## Upper Brant: S2 & Lower S1

Planning and Development Committee  
City of Burlington  
April 24, 2018  
R. Osborne

## One of the impacts is shadowing.....

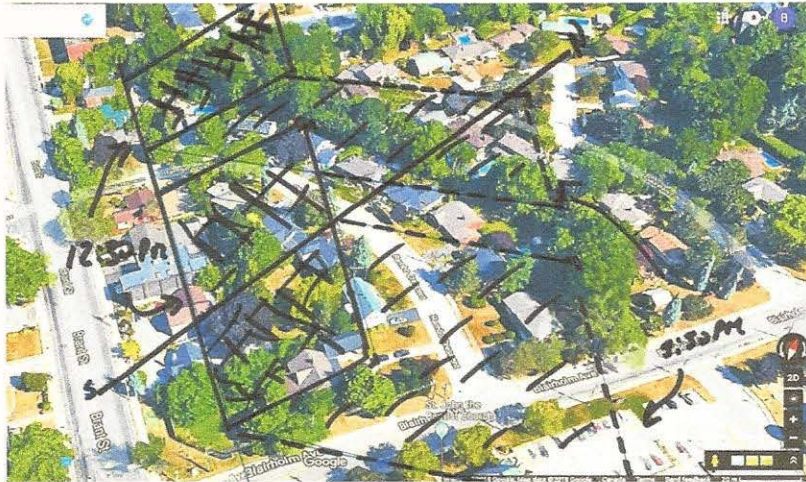
This sketch provides a simple shadow impact analysis for December 21 at 12:30 pm and 3:30 pm. Seven story buildings located in S2 and the lower part of S1 are assumed to be 25 m in height.

At 12:30 pm the shadow will be  $2.22 \times \text{building height} = 55 \text{ m}$  (affecting homes and properties abutting S1 and S2)

At 3:30 pm the shadow will be  $5.64 \times \text{building height} = 141 \text{ m}$  (affecting both sides of Rambo and extending into Courtland Place and St. John's parking lot.) (*National Research Council of Canada*)

S1 and S2 have been compared to Plains Road. The comparison is not valid. Properties on Rambo generally face south to southwest. Any structure built in S1 and S2 has the potential to block the sun.

Reducing height is a more effective way of reducing shadow impacts than setback.

Mississauga considers site orientation, height and neighbourhoods

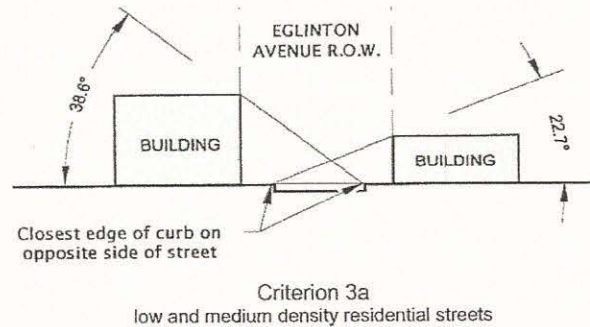
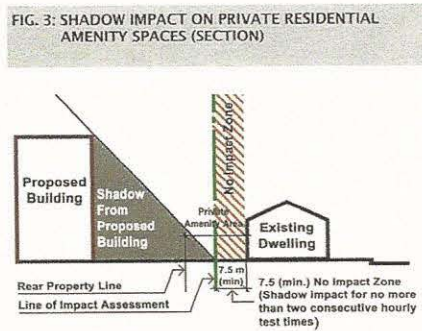
Mississauga's standards for shadow studies consider different factors. They set out no impact zones for residential properties. Building heights vary according to orientation of the proposed building relative to the sun and the surrounding area. Acceptable impact standards are set. (*Standards for Shadow Studies, City of Mississauga, August 2011*)

Burlington's Shadow impact requirements set out dates and times for analysis.
